June 27, 2013

Peach Bottom Atomic Power Station, Units 2 and 3
Renewed Facility Operating License Nos. DPR-44 and DPR-56
NRC Docket Nos. 50-277 and 50-278

Subject: Supplemental Information Supporting Request for License Amendment Request -
Extended Power Uprate – Supplement No. 5

RESIDUAL HEAT REMOVAL SYSTEM
CURRENT CONFIGURATION WITH RHR MODIFICATION CHANGES
FOR INFORMATION ONLY
NOT A CONTROLLED DRAWING

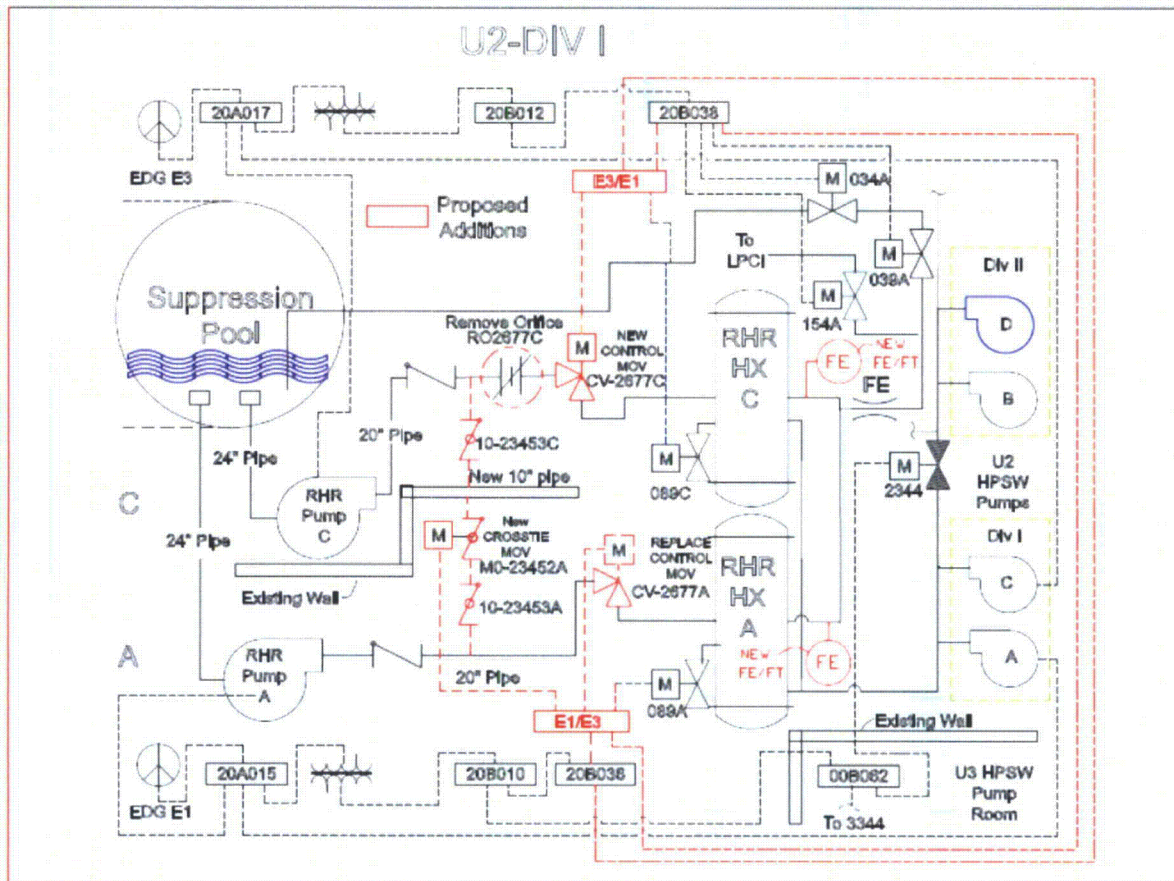
The revision includes an update to Figure 9c-1, RESIDUAL HEAT REMOVAL SYSTEM CURRENT CONFIGURATION WITH RHR MODIFICATION CHANGES, which shows the configuration changes being made to the RHR system as a result of EPU including those discussed in this supplement. It is provided in Enclosure 1a to this Attachment. The revision to Enclosure 9c also includes a new Figure 9c-2, RHR AND HPSW MODIFICATIONS SINGLE LINE ELECTRICAL DIAGRAM that is also provided in Enclosure 1a. Figure 9c-2 updates the sketch provided in the response to EEEB RAI-11 (Reference 5) by showing the alternate power supply capability that will be provided to the motor-operated RHR cross-tie, RHR flow control and RHR heat exchanger HPSW outlet valves.

BLACK lines show plant configuration prior to EPU

RED lines show the addition of the RHR Heat Exchanger Cross-Tie Modification including the transfer switch modifications.

RHR AND HPSW MODIFICATIONS SINGLE LINE ELECTRICAL DIAGRAM
FOR INFORMATION ONLY
NOT A CONTROLLED DRAWING

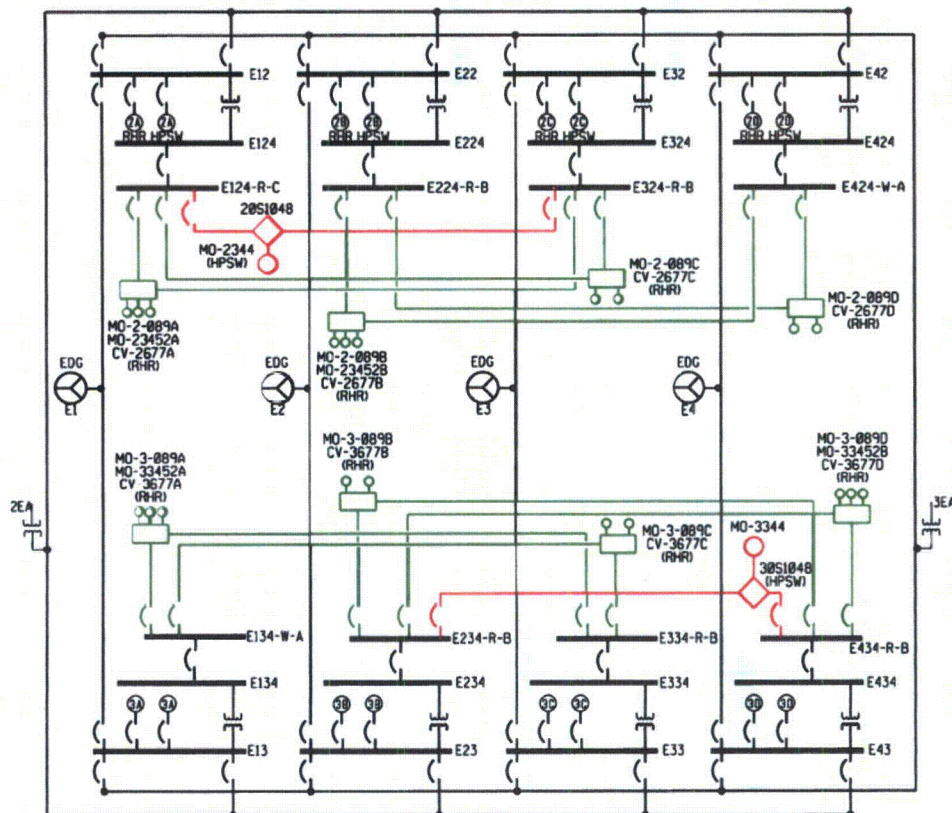
Figure 9c-2 is a schematic that shows the electrical one-line arrangement of the power sources for the motor-operated RHR cross-tie, RHR flow control and RHR heat exchanger HPSW outlet valves as well as for the motor-operated HPSW cross-tie valves described in Enclosure 9d.

BLACK lines show plant configuration prior to the EPU modification.

RED lines show the addition of the HPSW Cross-Tie transfer switch modification for EPU.

GREEN lines show the addition of the RHR Heat Exchanger Cross-Tie transfer switch modification for EPU.
